Product part number: SLG46400

Active SLG46400 Errata List

ISSUE 5: ACMP dynamic on/off glitches

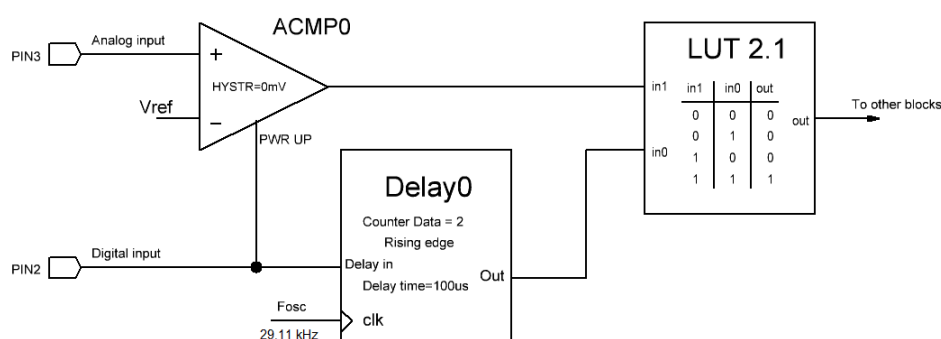
ACMP will have glitches on its output after being turned on during 100us maximum.

- Use 100us Deglitch Delay on the ACMP output (typically 100us both edges delay) or make a system of 100us rising edge Delay block and LUT to reject the ACMP output for 100us after its power up (See example below)

ISSUE 12: LUT starts with output high when the feedback from its output to IN0 is used.

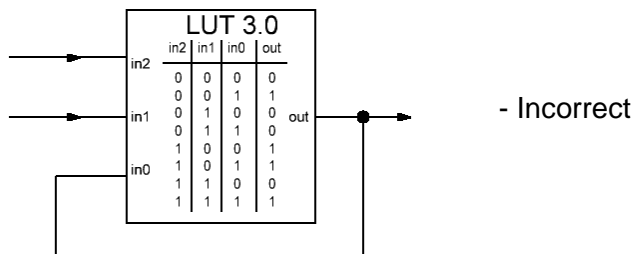
LUTs configured to have a feedback from its OUT to IN0 and truth table contains the situation, for 2-bit LUT IN1=0, IN0=1, OUT=1, for 3-bit LUT IN2=0, IN1=0, IN0=1, OUT=1, for 4-bit LUT IN3=0, IN2=0, IN1=0, IN0=1, OUT=1 can start with OUT HIGH (see example below).

ISSUE 14: DFF incorrect startup

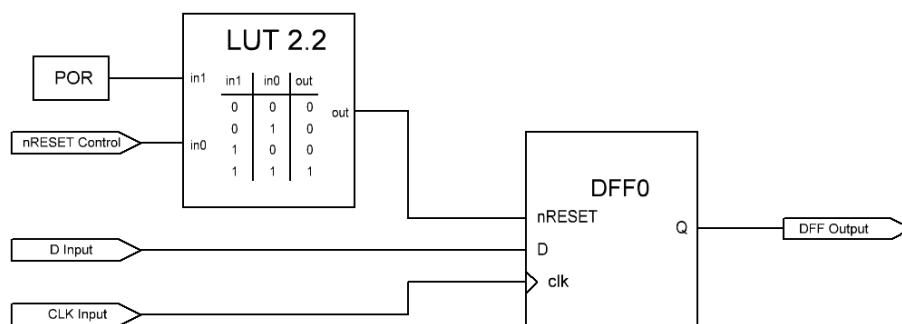
DFFs with nRESET/nSET can start (initialize) with different output states.

- Set DFF initial state before POR signal appears. Use similar connections as shown below

ISSUE 16: Incorrect Delay time

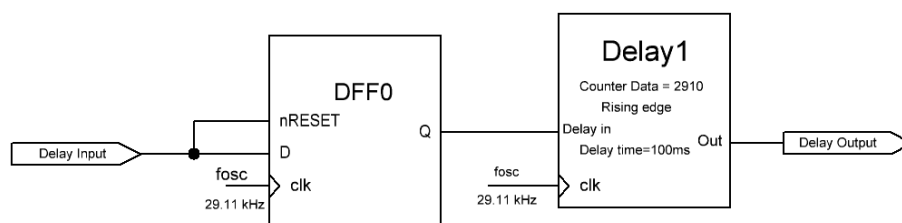
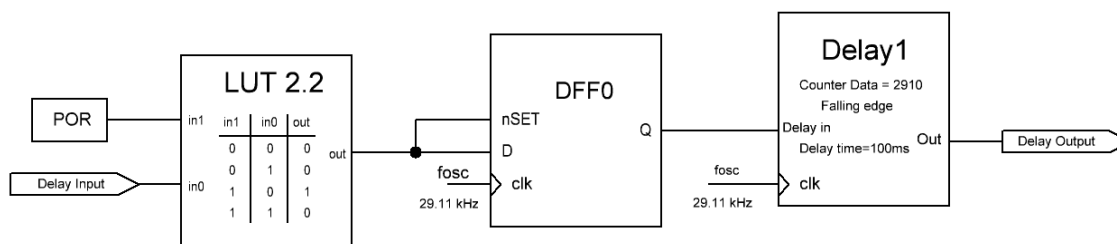
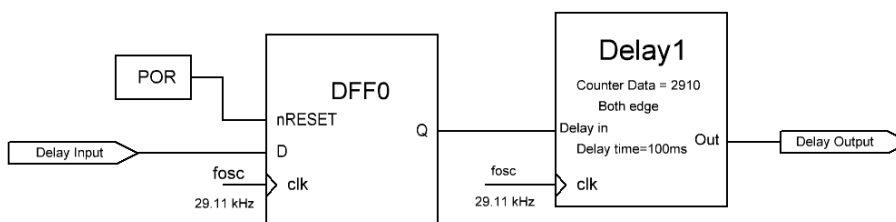
If the input edge of the Delay (or reset of Counter) is very close (<1ns) to the rising edge of the sourced clocking signal (RC OSC is Forced Power On or operating because another blocks request) the Counter/Delay cell might have incorrect Counter Data loaded.

- Use synchronization block on the Counter/Delay input, similar to that shown below.
In case of Rising Edge Delay:

In case of Falling Edge Delay:

In case of Both Edges Delay:

ISSUE 18: Counter with external clock starts internal RC OSC operation when reset

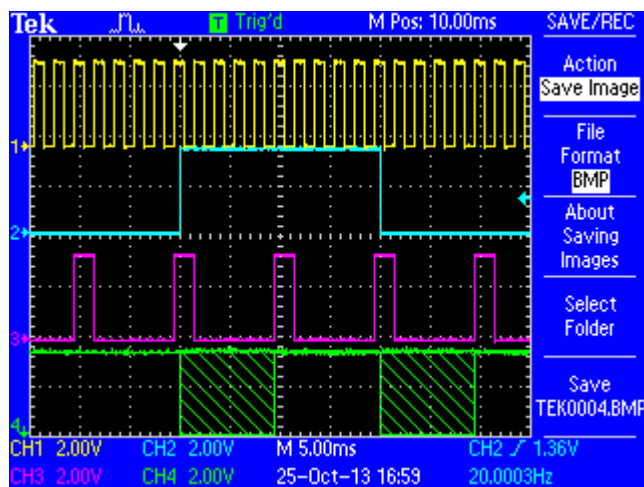
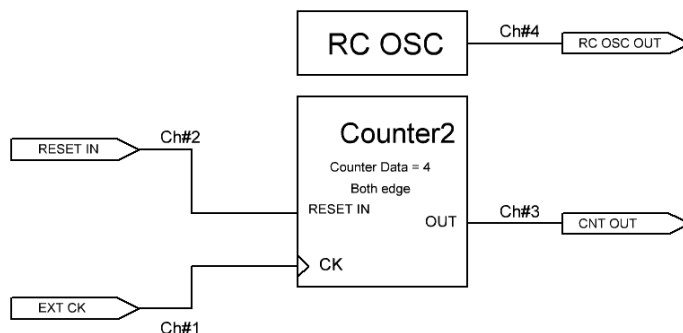
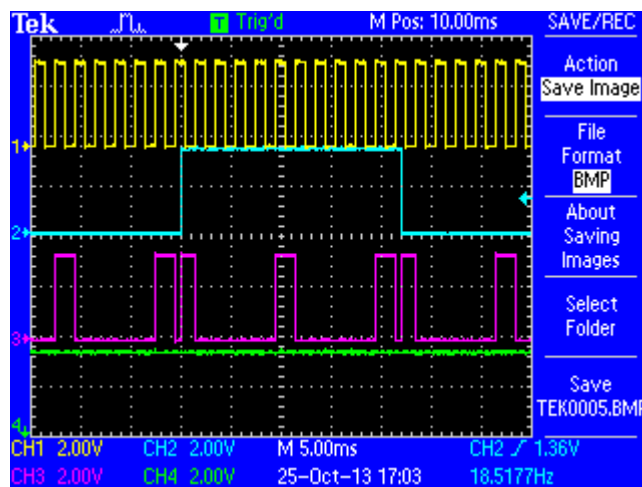
CNT2 and CNT3 (FSM0 and FSM1) have a possibility to be sourced from external RC OSC signal and have RESET signal at the same time. While block is in a reset state (when finished counting cycle and output is logic HIGH) and the defined RESET edge appears the internal RC OSC will start its operation until counter enters the next reset state.

Reset Edges came up with Reset state

Reset Edges and Reset state are at a different time

- Currently there is no universal workaround. If the RSC should be powered down all the time its Shared Power Down can be set to be controlled from matrix and SHARED PD input connected to HIGH level source.
